ANNEX 8**RESOLUTION MSC.222(82)****(adopted on 8 December 2006)****ADOPTION OF AMENDMENTS TO THE INTERNATIONAL CODE
OF SAFETY FOR HIGH-SPEED CRAFT, 2000**

**AMENDMENTS TO THE INTERNATIONAL CODE OF SAFETY
FOR HIGH-SPEED CRAFT, 2000**

Figure 2.6.7a

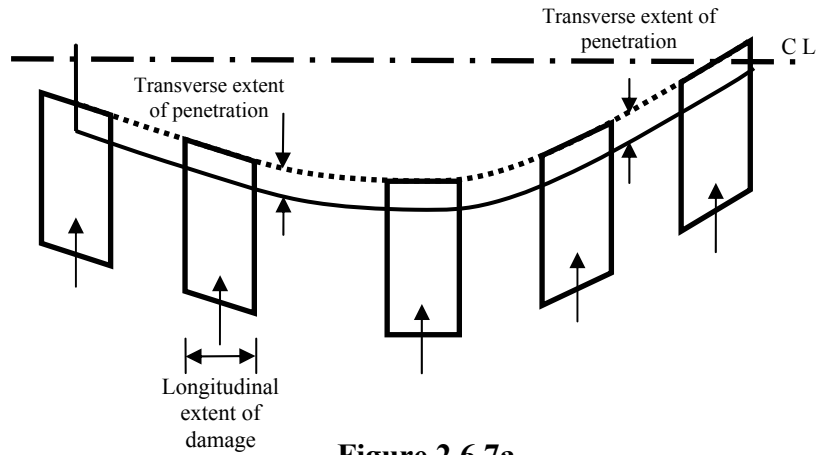
24 The following new section of text is added in continuation of paragraph 2.6.7 after subparagraph 2.6.7.3:

“The damages described in this paragraph shall be assumed to have the shape of a parallelepiped.* Applying this to figure 2.6.7 a, the inboard face at its mid-length shall be tangential to, or otherwise touching in a least 2 places, the surface corresponding to the specified transverse extent of penetration, as illustrated in figure 2.6.7 a.

Figure 2.6.7 b

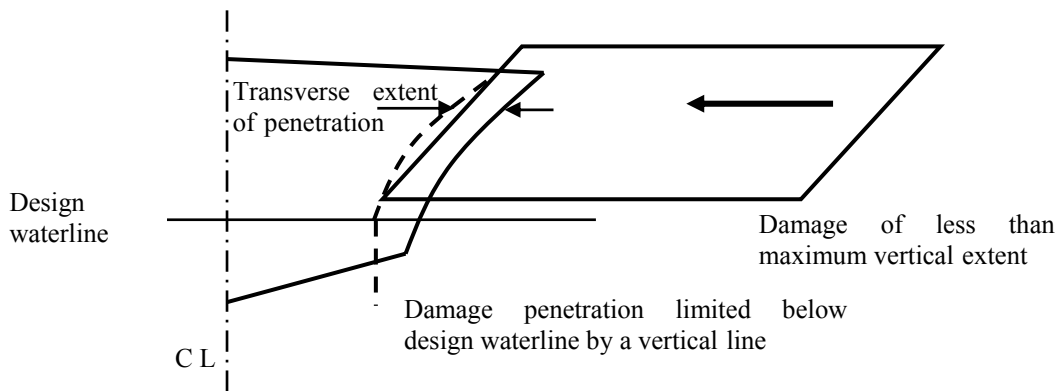
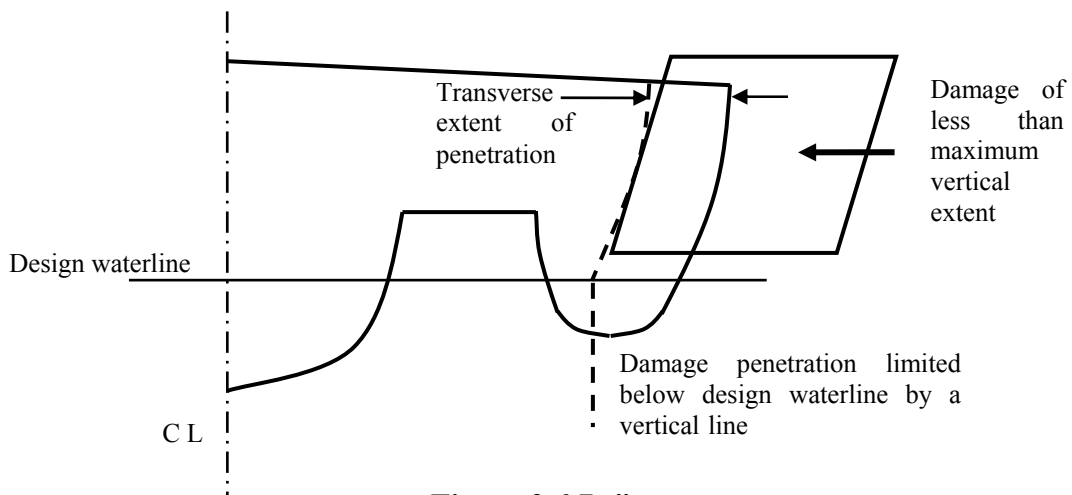
Side damage shall not transversely penetrate a greater distance than the extent of $0.2\nabla^{1/3}$ at the design waterline, except where a lesser extent is provided for in 2.6.7.2. Refer to figures 2.6.7b and c.

Figure 2.6.8”

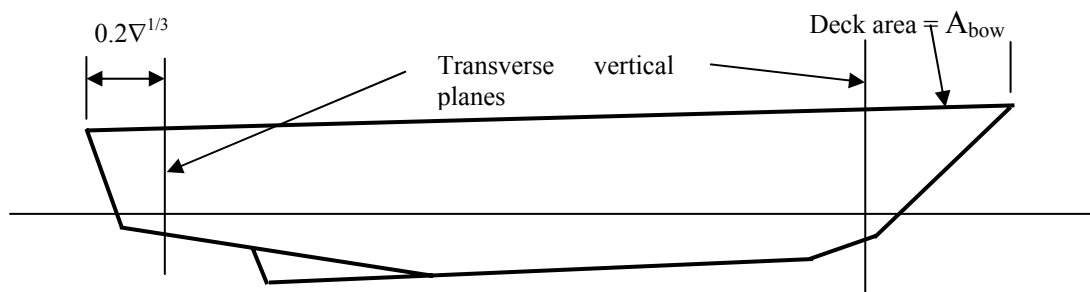
26 Existing paragraphs 2.6.8 to 2.6.12 are renumbered as paragraphs 2.6.9 to 2.6.13 and the following new paragraph 2.6.8 is inserted after the existing paragraph 2.6.7:

“2.6.8 Extent of bow and stern damage

2.6.8.1 The following extents of damage are to be applied to bow and stern, as illustrated in figure 2.6.8:

- .1 at the fore end, damage to the area defined as A_{bow} in 4.4.1, the aft limit of which being a transverse vertical plane, provided that this area need not extend further aft from the forward extremity of the craft’s watertight envelope than the distance defined in 2.6.7.1; and
- .2 at the aft end, damage to the area aft of a transverse vertical plane at a distance $0.2\nabla^{1/3}$ forward of the aft extremity of the watertight envelope of the hull.

Figure 2.6.9.2

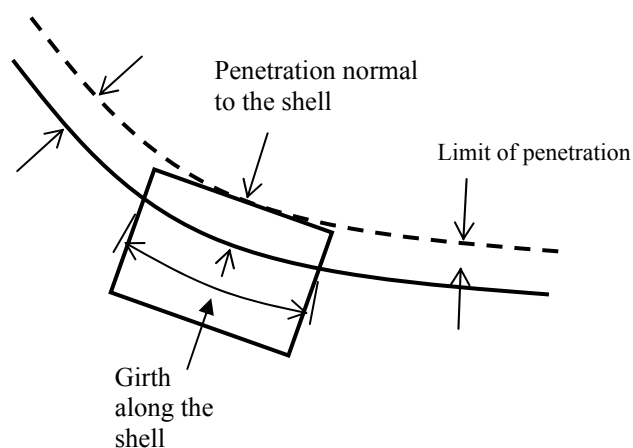
29 The following new paragraph 2.6.9.2.3 is inserted after the existing paragraph 2.6.9.2.2:

“2.6.9.2.3 The shape of damage shall be assumed to be rectangular in the transverse plane as illustrated in figure 2.6.9.2 below. Damage is to be assumed at a series of sections within the defined longitudinal extent in accordance with figure 2.6.9.2, the mid-point of the damaged girth being maintained at a constant distance from the centreline throughout that longitudinal extent.

“.4 the shape of damage shall be assumed to be rectangular in the plane of the shell of the craft, and rectangular in the transverse plane as illustrated in figure 2.6.9.2.”

Figure 7.3.4a

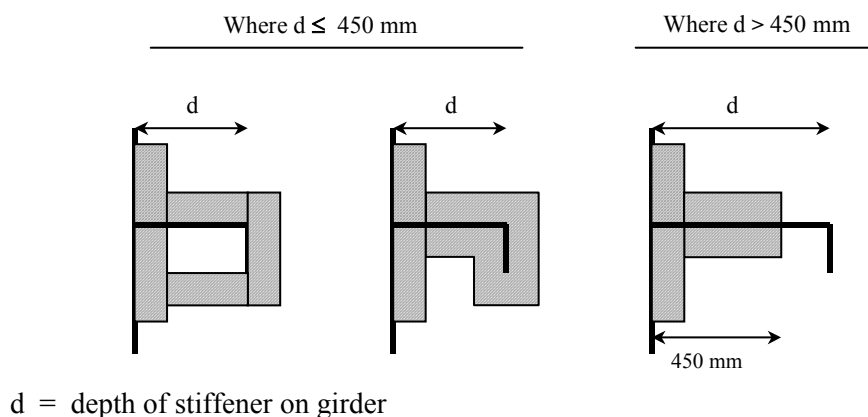
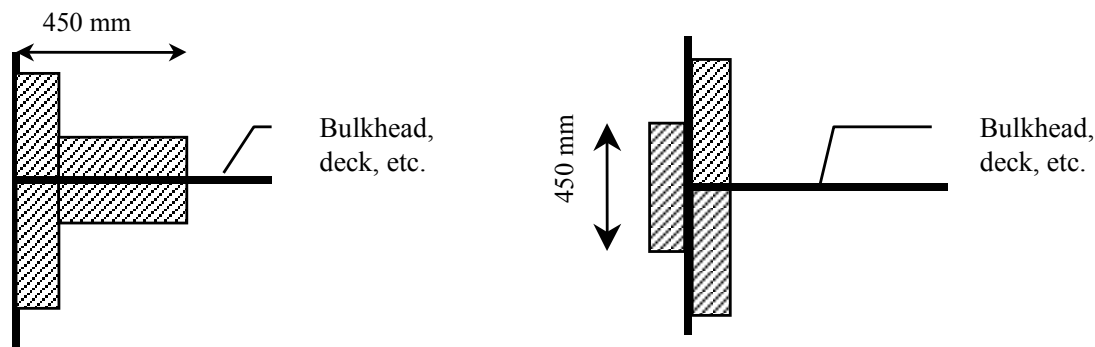
55 The following new paragraphs 7.3.4 to 7.3.6 and associated figures 7.3.4a, 7.3.4b and 7.3.6 are inserted after the existing paragraph 7.3.3:

“7.3.4 To prevent heat transmission at intersections and terminal points, the insulation of the deck or bulkhead shall be carried past the intersection or terminal point for a distance of at least 450 mm in the case of steel or aluminium structures (refer to figures 7.3.4a and 7.3.4b).
